# Deficiencies in the TEPCO plan to discharge contaminated water into the Pacific Ocean

Arjun Makhijani, Ph.D.,

December 16, 2022

Based on the Expert Panel Memorandum to the Pacific Islands Forum of  
August 11, 2022

Sr-90/Cs-137 for ALPS Treated Water

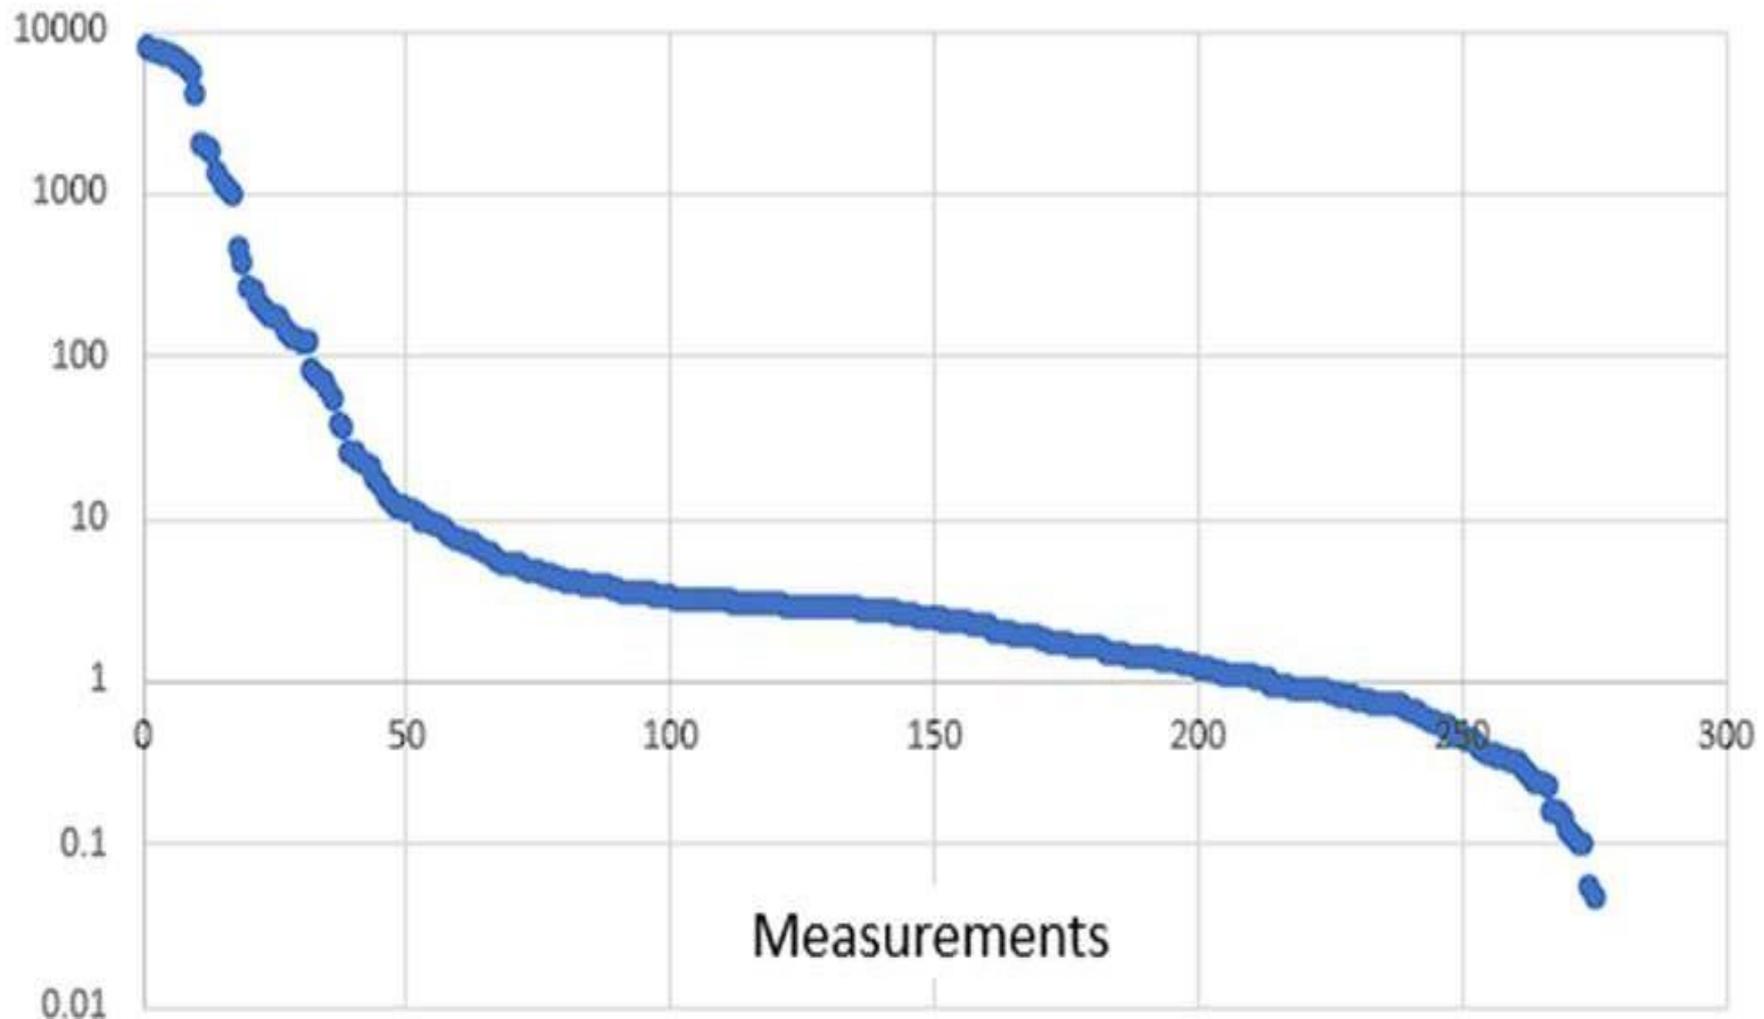
Sr-90/Cs-137 unexplained variability. Is there a problem with ALPS treatment? Irregular performance? Varied sources of water?
